UNITED STATES PATENT AND TRADEMARK OFFICE

APPLICATION NO.	FILING DATE	FIRST NAMED INVENTOR	ATTORNEY DOCKET NO.	CONFIRMATION NO.
10/585,652	04/29/2009	Arno Schubert	PF040001	5465
24498	7590	09/30/2010		
Robert D. Shedd, Patent Operations THOMSON Licensing LLC P.O. Box 5312 Princeton, NJ 08543-5312			EXAMINER MAHONEY, CHRISTOPHER E	
			ART UNIT	PAPER NUMBER
			2862	
			MAIL DATE	DELIVERY MODE
			09/30/2010	PAPER

Office Action Summary	Application No. 10/585,652	Applicant(s) SCHUBERT ET AL.	
	Examiner Christopher E. Mahoney	Art Unit 2862

DETAILED ACTION

FIG. 10

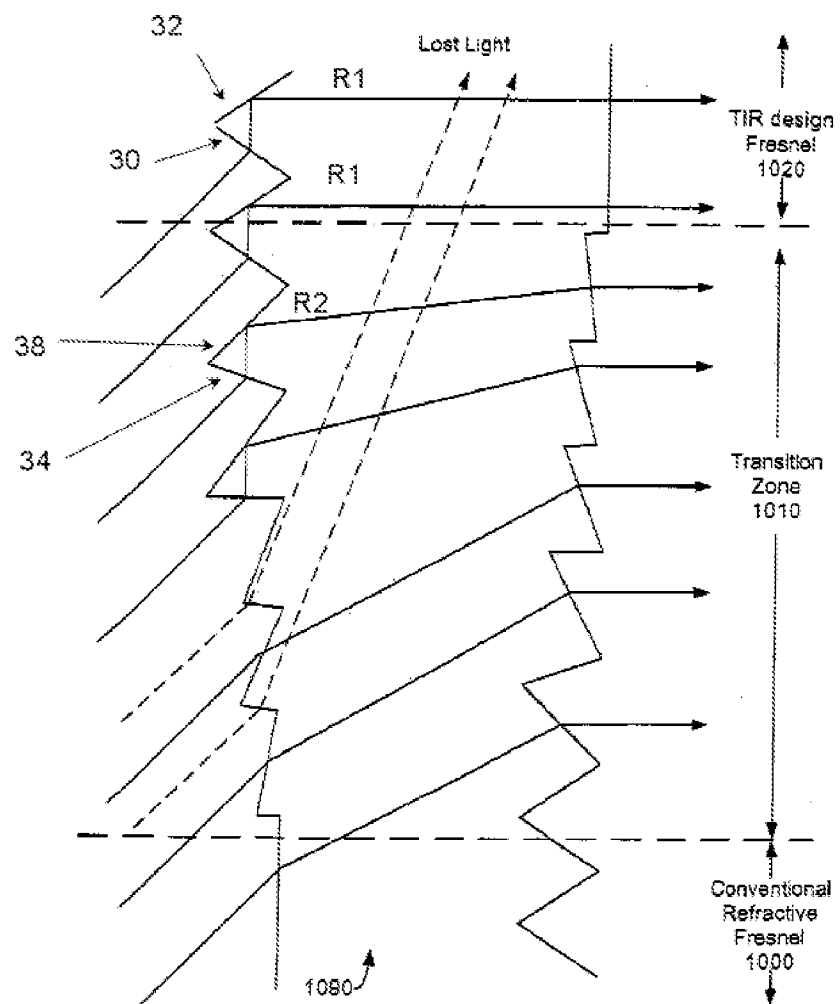
Claims 1-5, 8-10 and 14 are rejected under 35 U.S.C. 102(e) as being anticipated by Peterson (U.S. Pat. No. 7102820). Peterson teaches means of generating an image (DMD 350/1130); means of projecting the image (Lens system 340/1120) onto a screen (figs. 3, 11) the screen comprising a Fresnel lens (fig 10) said Fresnel lens including at least one first area comprising first prisms each first prism having a first side (30 annotated figure below) and a second side (32 annotated figure) which forms with a main axis an angle greater than that formed by the first side and the main axis AA, the second side of the first prism being designed to collimate (see R1 in annotated figure below), in line with the main axis an incident ray from said projection means, said Fresnel lens having symmetry of revolution about said main axis (circular Fresnel lens, also see fig. 6), wherein said Fresnel lens includes one second area comprising second prisms each second prism having a first side (34) and a second side (38) which forms with a main axis an angle greater than that formed by the first side and the main axis the second side of the second prism being designed to transmit, in a first direction (R2) different from the main axis an incident ray from said projection means.

While it is understood that the light exiting the Fresnel lens depicted in figure 10 ends up all collimated, the annotated figure below illustrates how the Peterson reference anticipates the claim language. R2 is divergent from the main axis.

Alternatively, the second prisms could be even lower (closer to the main axis) in the figure below. Regarding claims 9 and 10, if the second prisms are in the lower portion of Transition zone 1010, then the second prisms are working in a refractive mode.
